3GPP TSG CN Plenary Meeting #22
10th – 12th December 2003 Maui, USA.

NP-030498

Source: TSG CN WG4
Title: Corrections on Location Services
Agenda item: 7.4
Document for: APPROVAL

Spec	CR	Rev	Doc-2nd-Level	Phase	Subject	Cat	Ver_C
29.010	093		N4-031164	Rel-4	Wrong message appears in message flow	F	4.6.0
29.010	094		N4-031165	Rel-5	Wrong message appears in message flow	A	5.4.0
29.010	095		N4-031166	Rel-6	Wrong message appears in message flow	A	6.0.0

Figure 68cb: Signalling for the request of Assistance Data or De-ciphering Keys

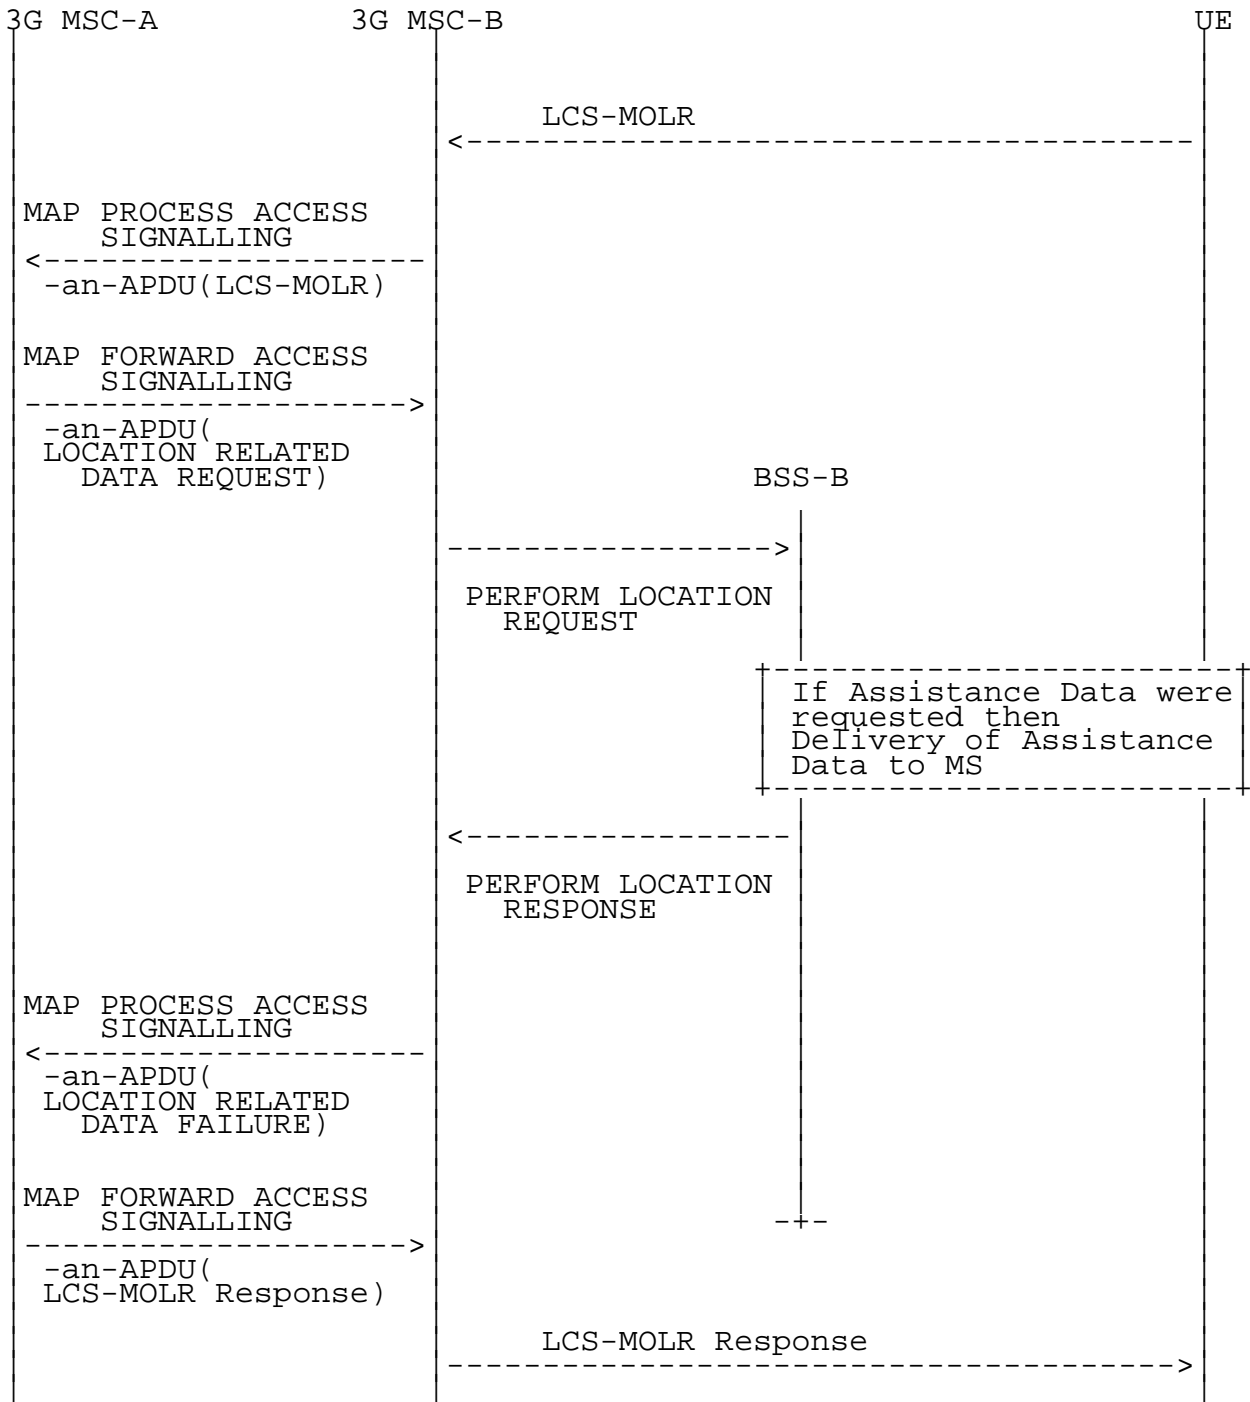
If the request fails, either because the BSS-B cannot return the requested De-ciphering Keys to the anchor 3G MSC or BSS-B cannot deliver the required Assistance Data to the MS, the signalling is as shown in figure 68**cb**.
